TITLE	PARTIAL MEZZANINE/LOW ROOF FRAMING PLAN - AREA B (SEQ-1)		
MADE BY	DATE	CONTRACTOR	JOB No.
PDS	11/30/2020		20028
CHKD BY	DATE	ARCHITECT	ENGINEER
JSY	11/30/2020		
			SHEET NO.
			1E1
			REV.
			A

**PARTIAL MEZZANINE/LOW ROOF FRAMING PLAN @ AREA-B (SEQ-1)**  
 (REF: S2.2 & 1/A1.3)  
 [TOP OF STEEL ELEVATION 114'-0 1/2" U.N.O.]

TITLE	BRACE ELEVATIONS @ AREA-B		
MADE BY	DATE	CONTRACTOR	JOB No.
PDS	11/30/2020		20028
CHKD BY	DATE	ARCHITECT	ENGINEER
JSY	11/30/2020		
			SHEET NO.
			1E10
			REV.
			A

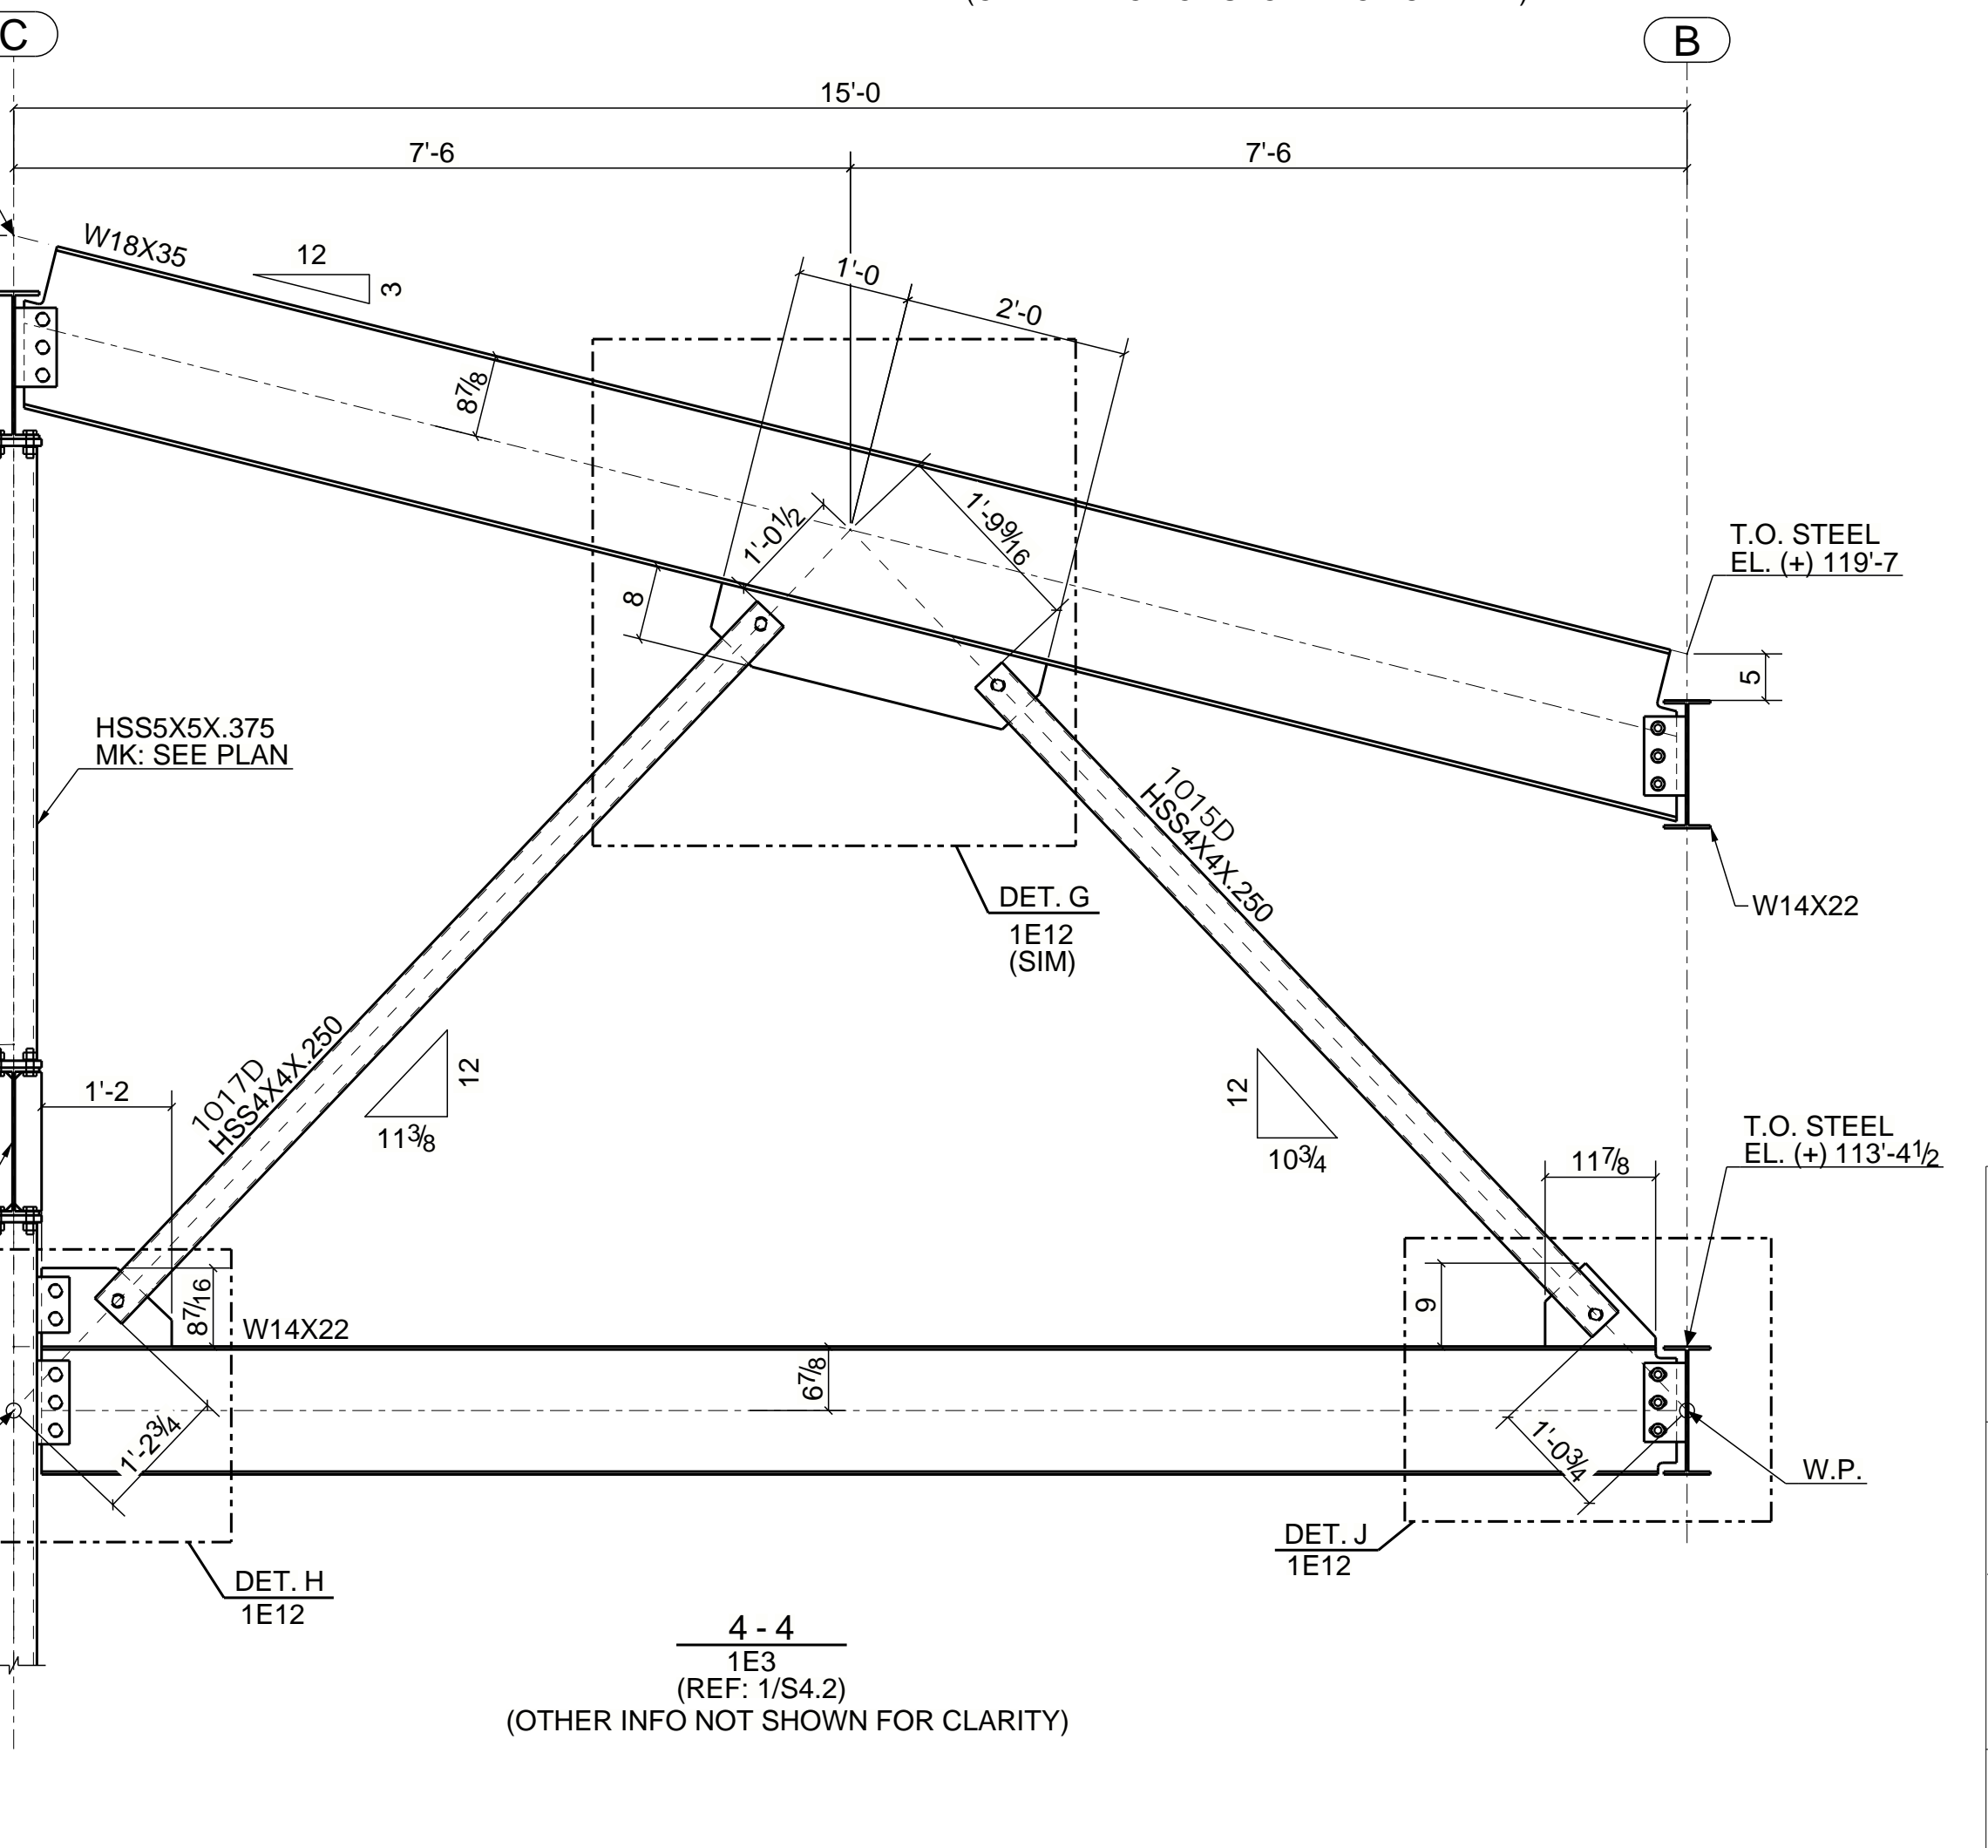
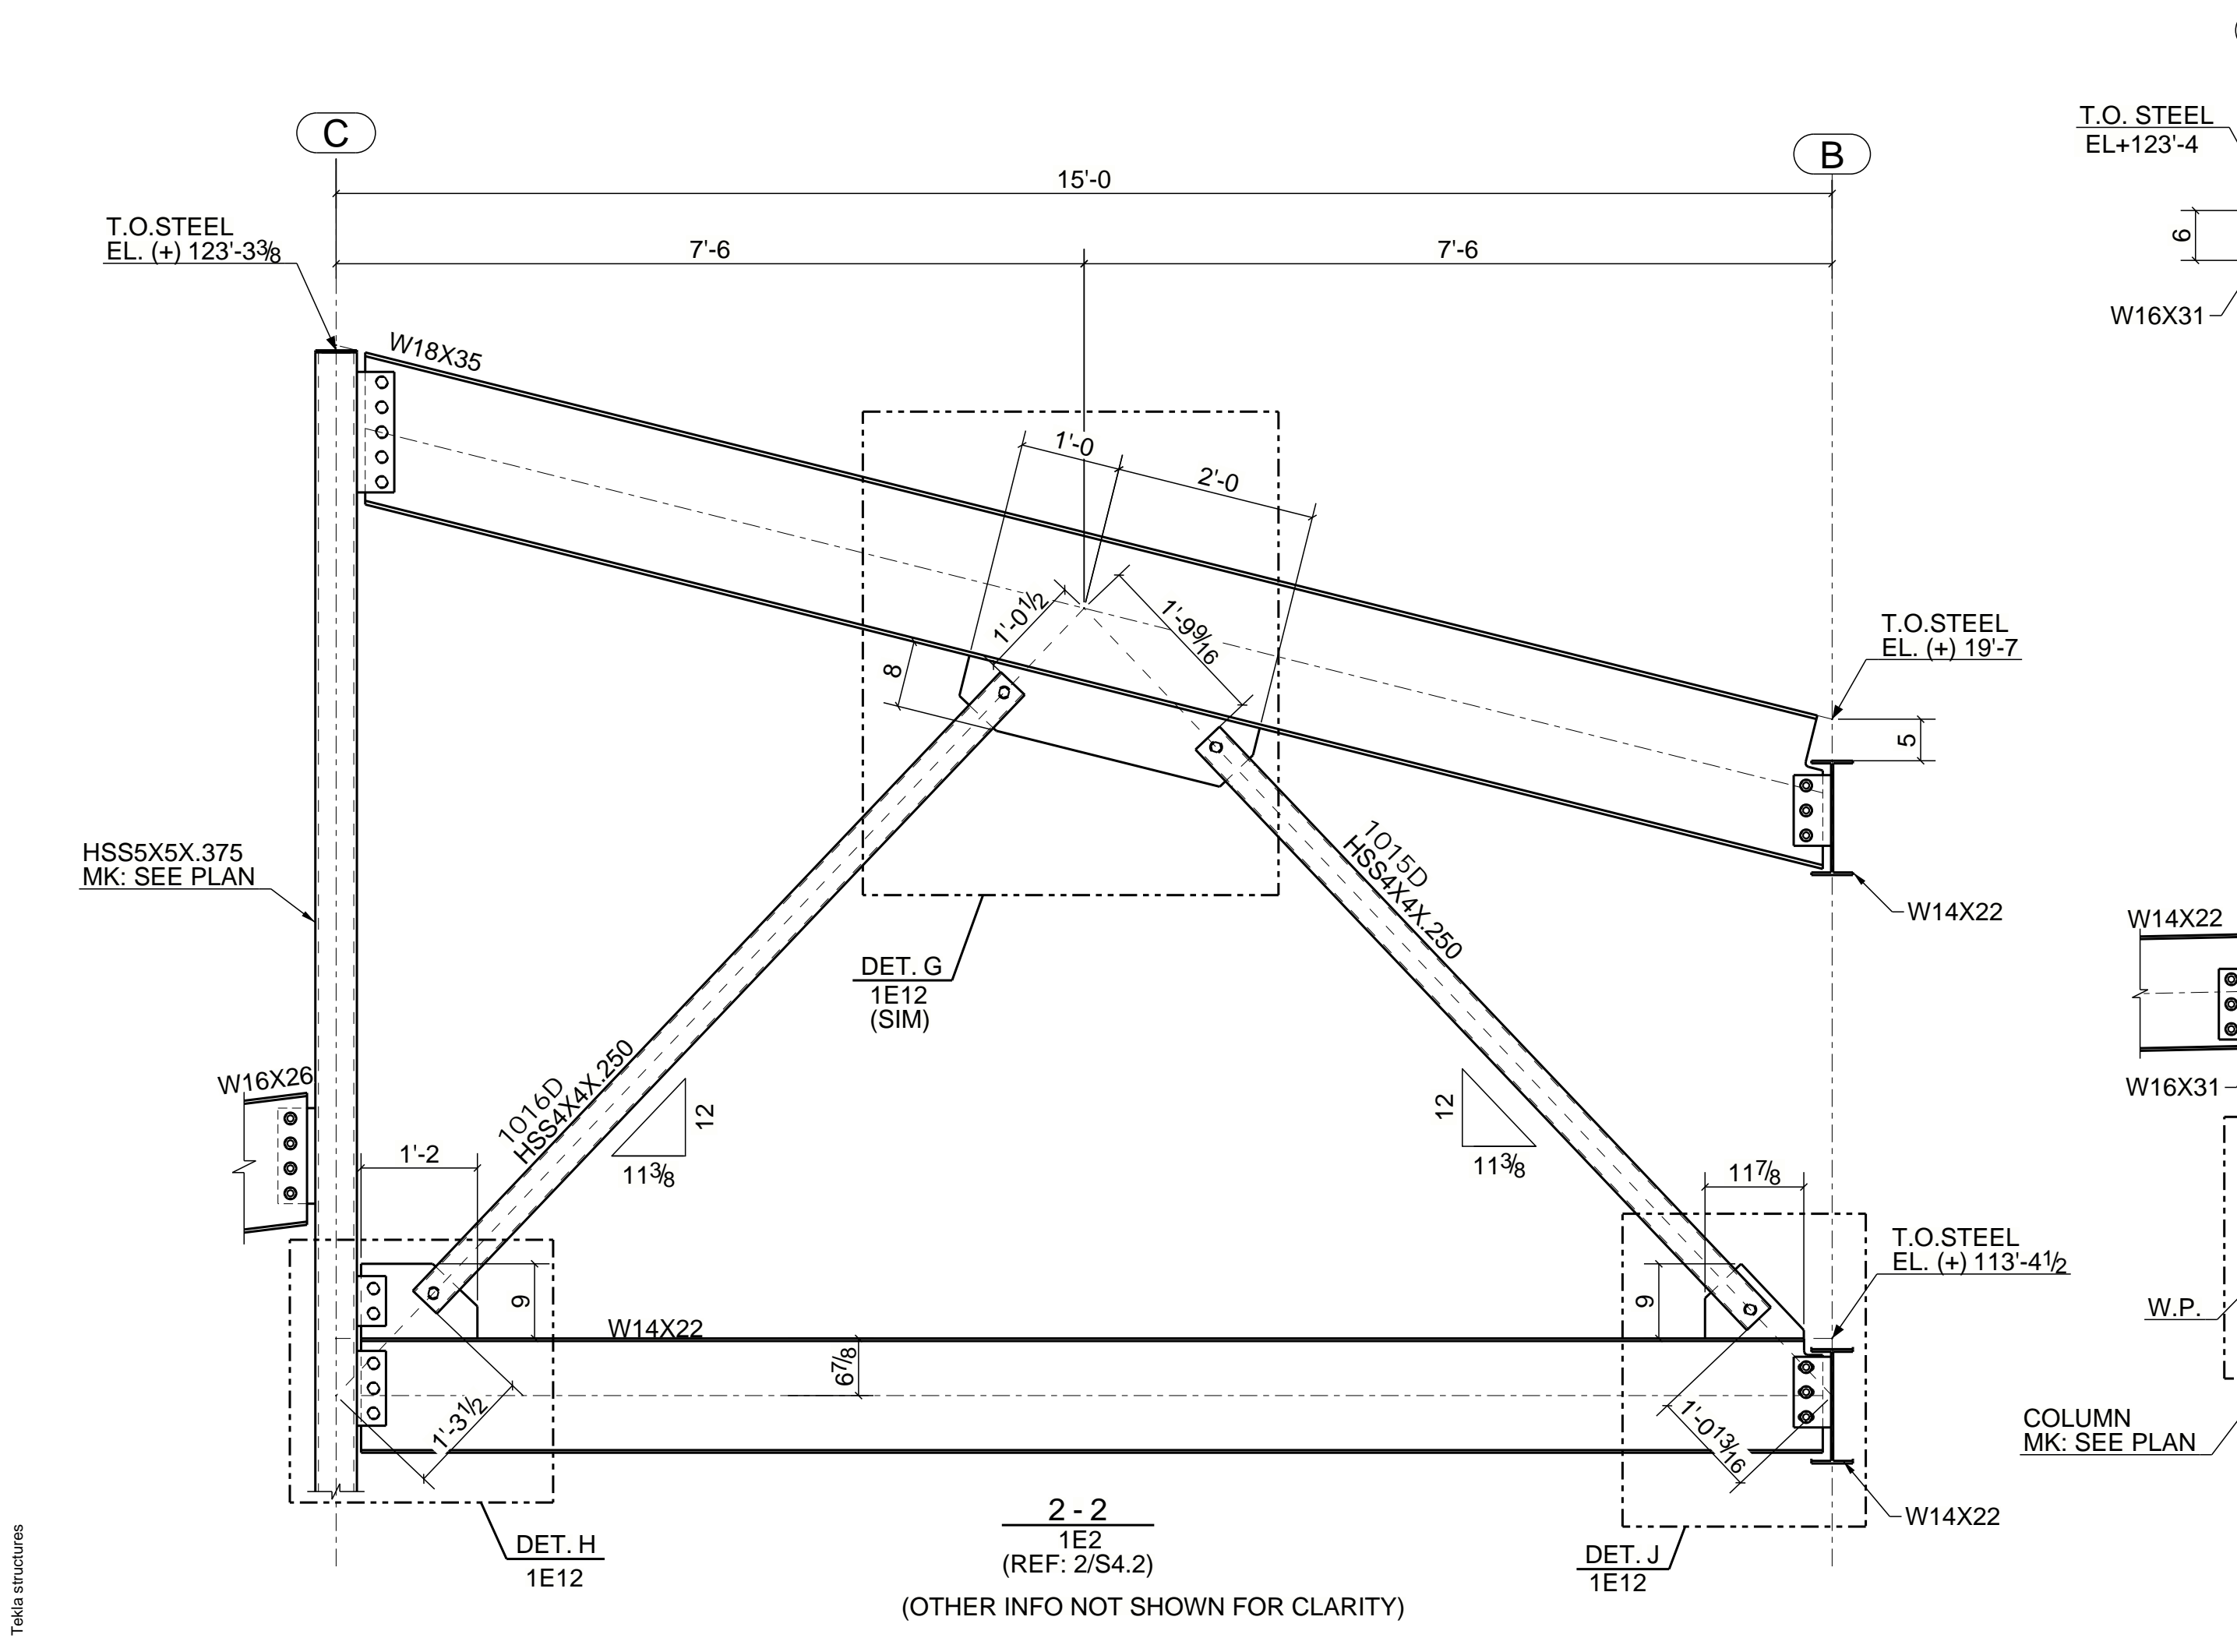
**APPROVER NOTE:-**  
 NOTE#1:- REFER STRU DRAWING S4.2. BRACE DETAIL 6/S4.2 SHOWS CONNECTION TYPE "20C". BUT WE HAVE FOLLOWED CONNECTION TYPE "20F" SIMILAR TO BRACE DETAIL 1&2/S4.2. PLEASE VERIFY/CONFIRM.
